## DESCRIPTIVE REPORT

Field No. ECFP-05255 Office No. H-8258

Locality Jordan Point to Factory Island

REVIEW OF HYDROGRAPHIC SURVEY

Chart - 120

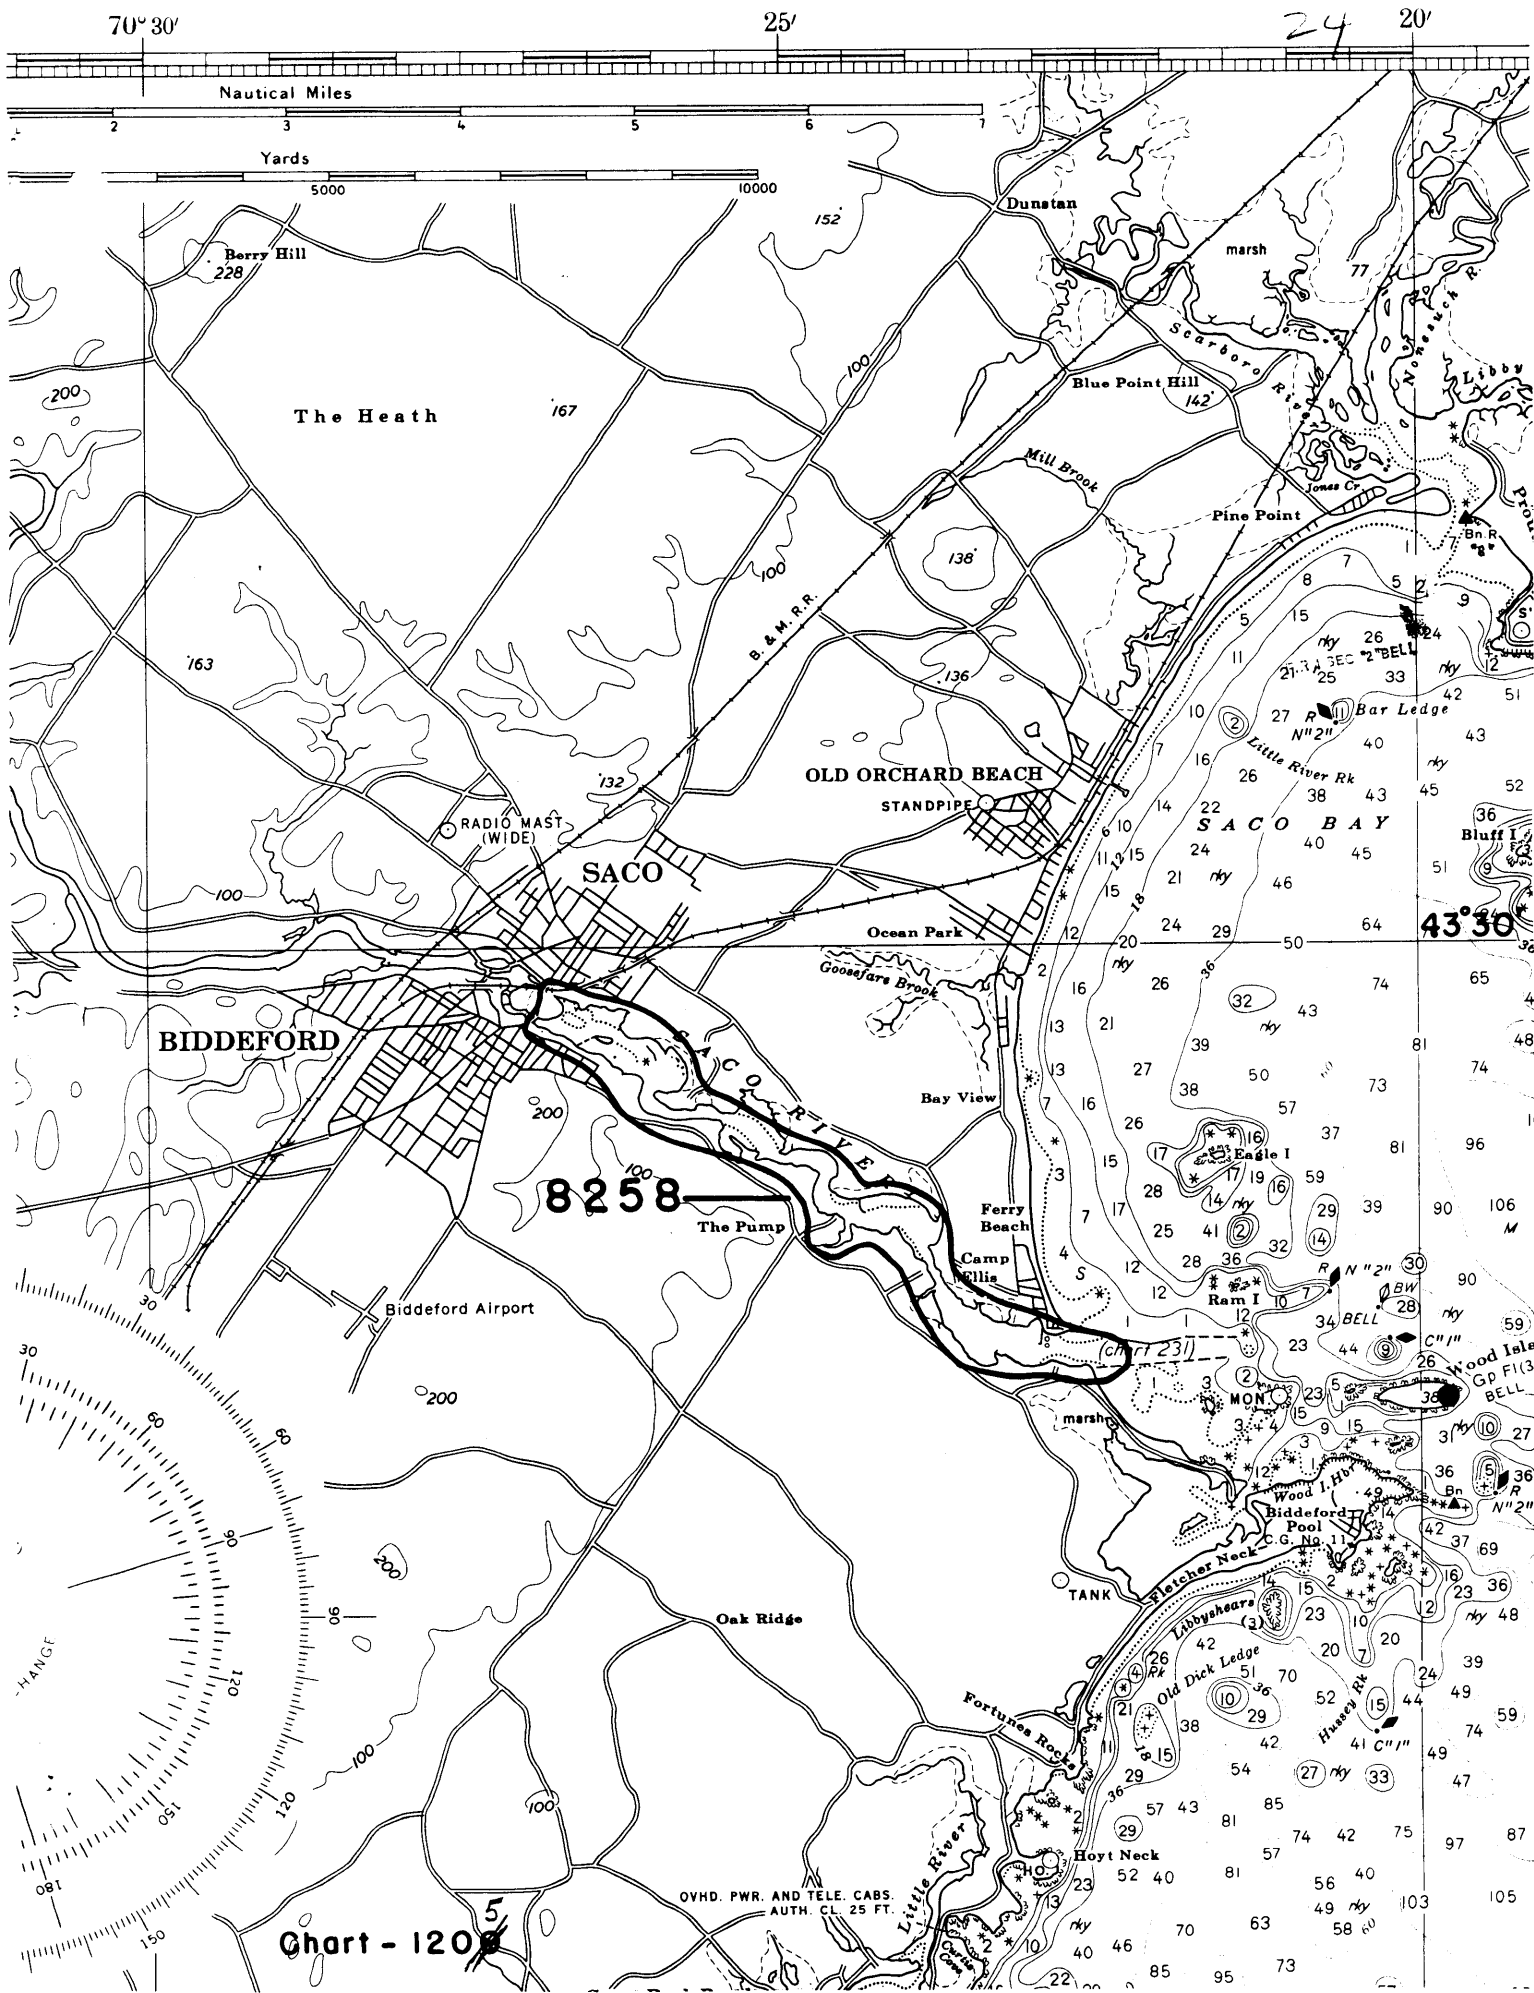
The "reduced soundings" should be changed as listed below:

<u>Positions</u>	<u>Change</u>	
1c-145d (purple)	Decrease by 1 foot	} questioned this information S. Rose
1a-38a	Increase by 2 feet	
43a-65a	Increase by 1 foot	
75a-94a	Increase by 1 foot	
95a-100a	Increase by 2 feet	
Nov. 11, 1955 Vol. No. 4 "a" day (blue)		
	DECREASE

<u>Positions</u>	<u>Change</u>
1d-14d	Decrease by 0.6 foot
15d-50d	Decrease by 0.8 foot
56a-60a	Increase by 0.8 foot
61a-65a	Increase by 0.6 foot
66a-67a	Increase by 0.4 foot
68a-75a	Decrease by 0.4 foot
76a-81a	Decrease by 0.6 foot
82a-85a	Decrease by 0.8 foot
87a-90a	Decrease by 1.2 feet
91a-94a	Decrease by 1.4 feet
95a-97a	Decrease by 1.6 feet
98a-100a	Decrease by 2.0 feet
"a" day (blue)

↑  
used these correctors  
S. Rose
